**Job: Chicago Woman's Park - GFRC
Terra Cotta Keystone
Replacement**

Drawing Record
Drawing Submittal - 4/26/2013

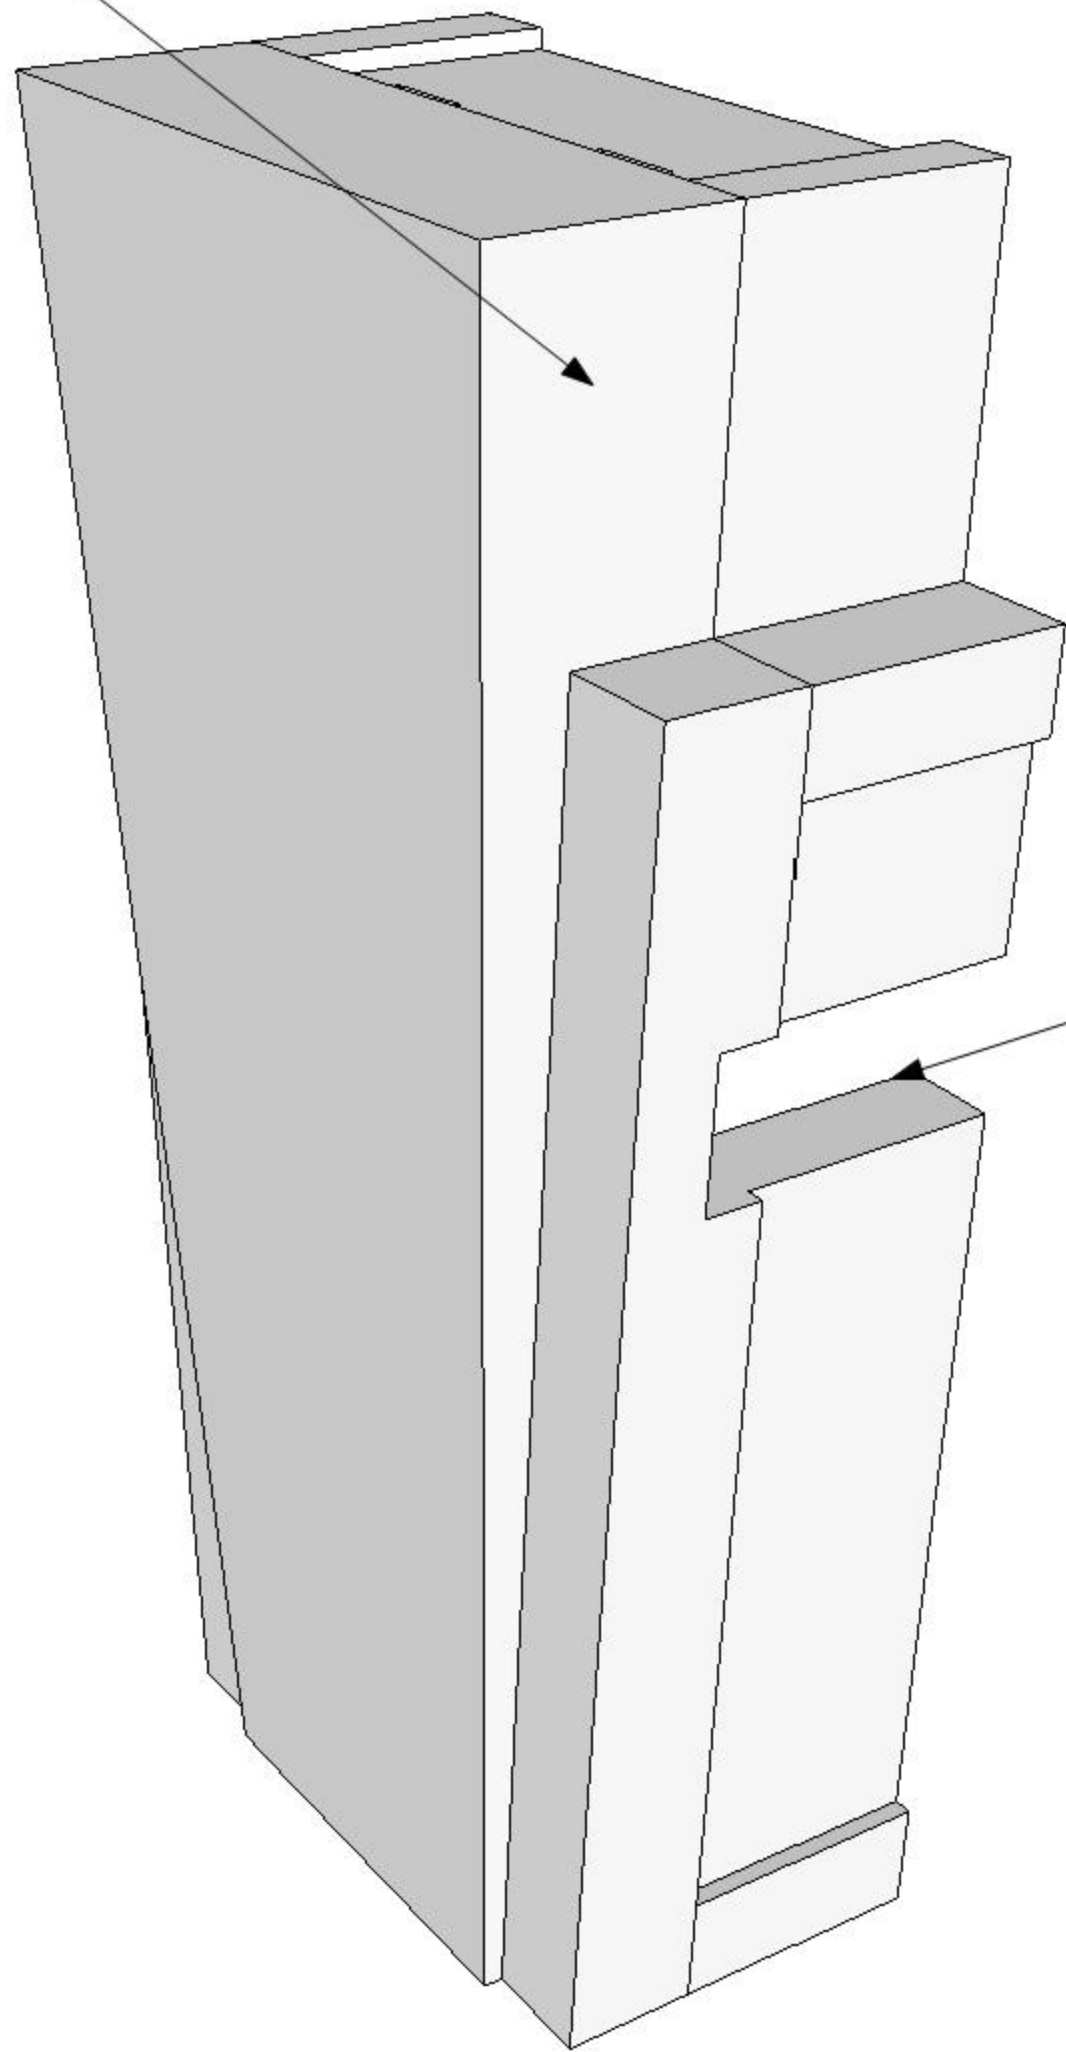
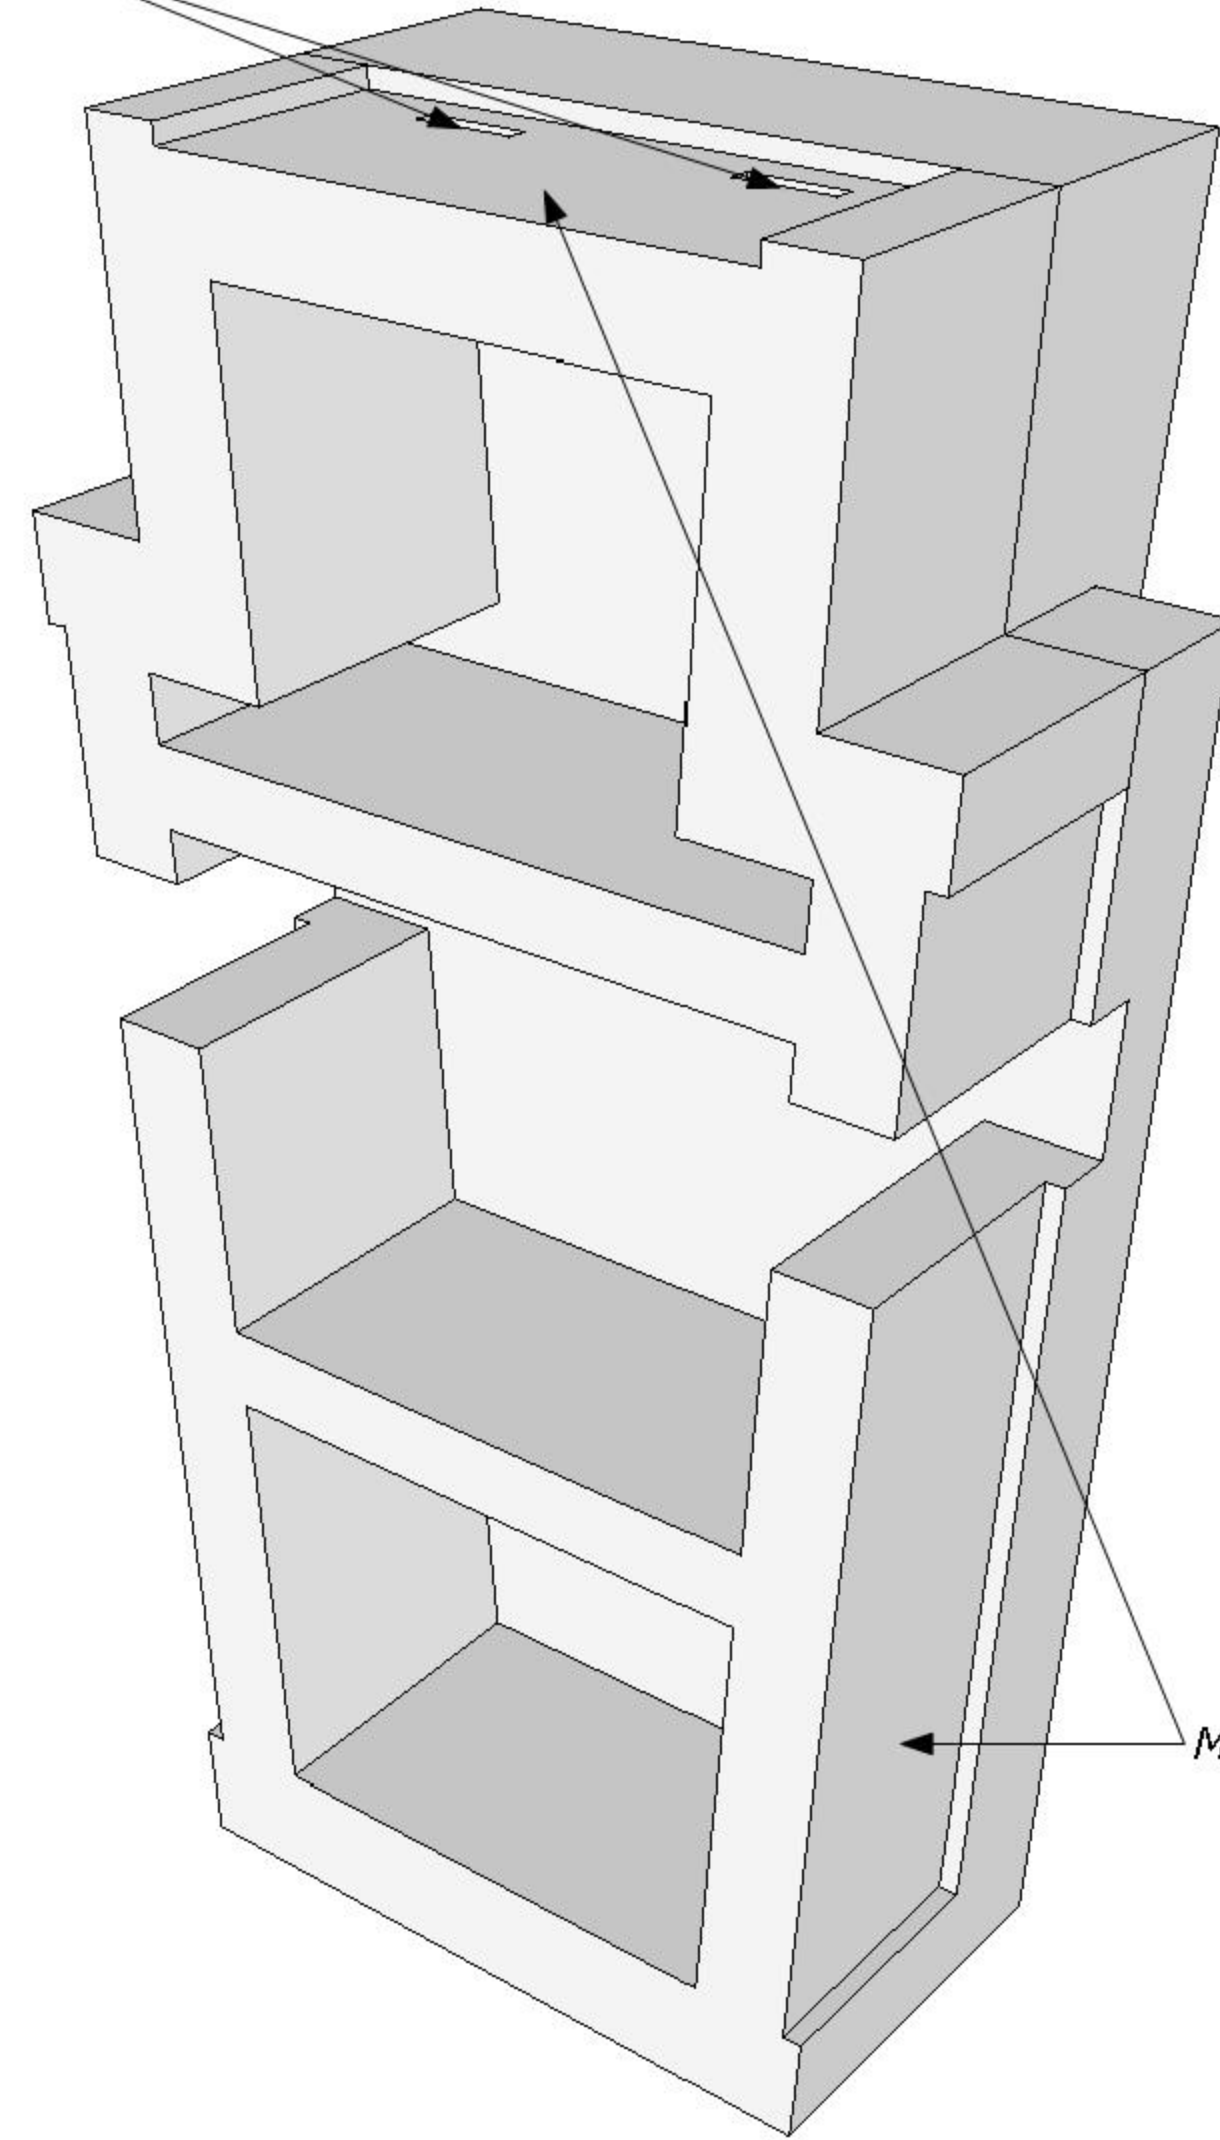
See fragment for
finished/exposed surface
on sides of piece

Contractor to advise
on notchout requirements.
Drawing reflects the provided
fragment

Strap notchout locations
per fragment

C :: Back View
101 scale: 3"=1"

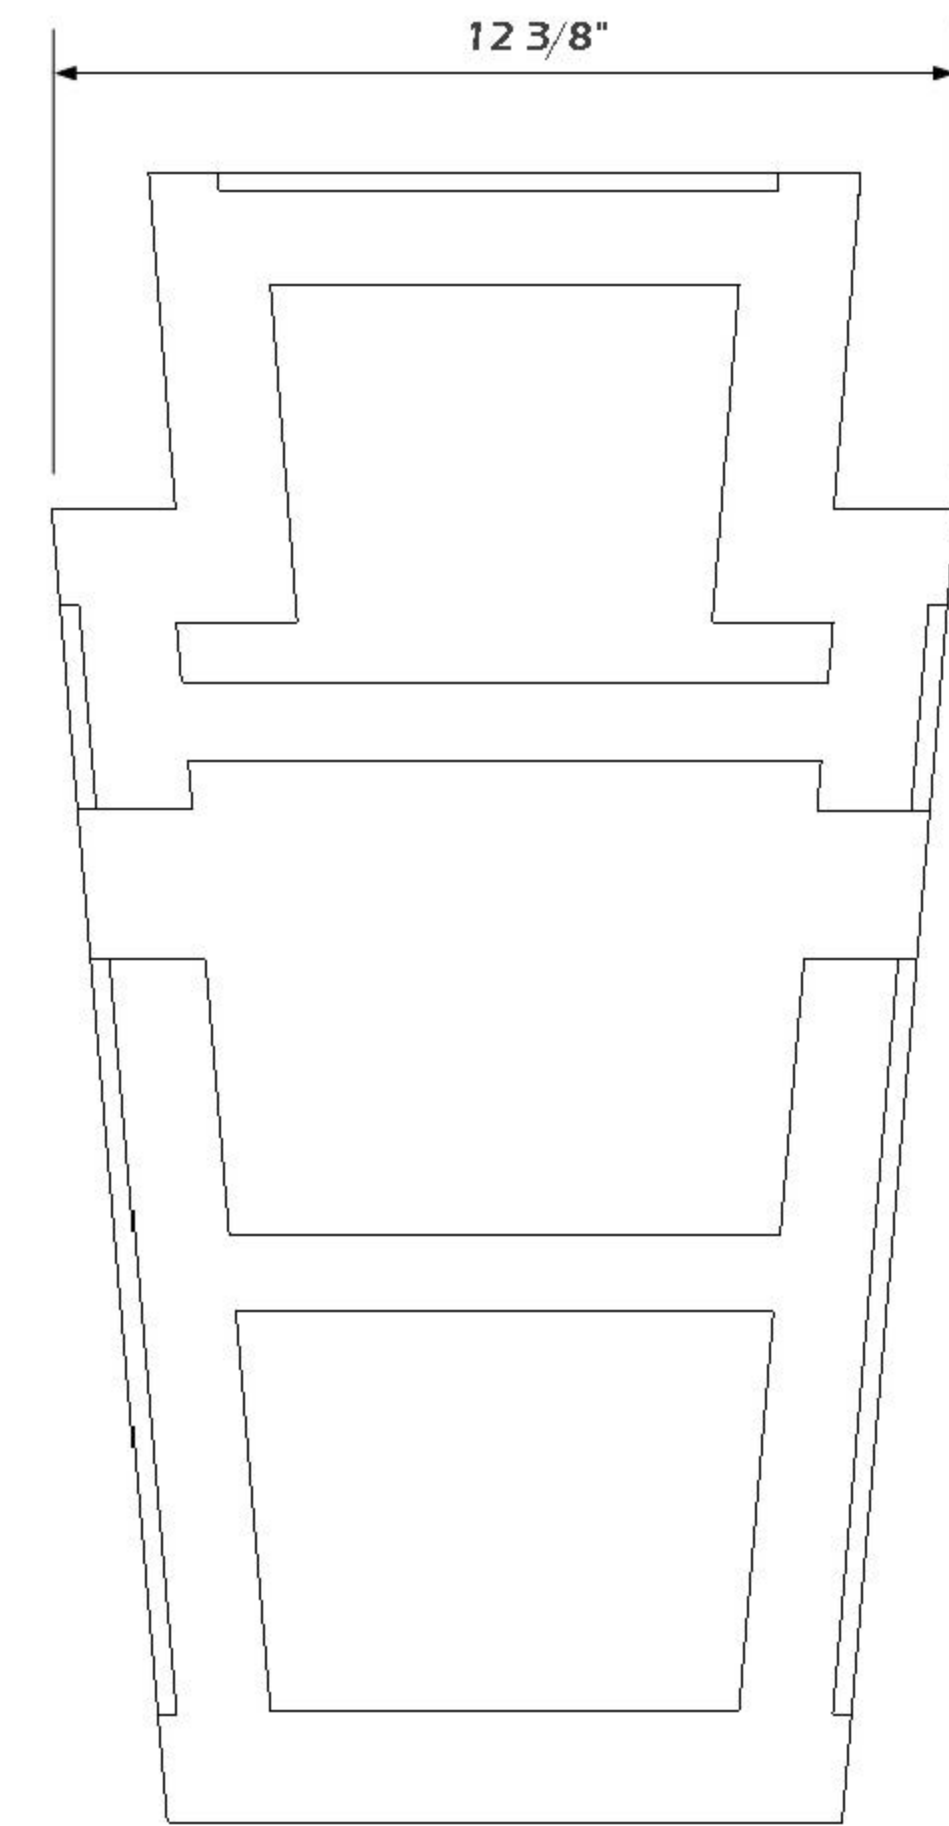
NOTE: per fragment provided, steel notchout extends past exposed surface.
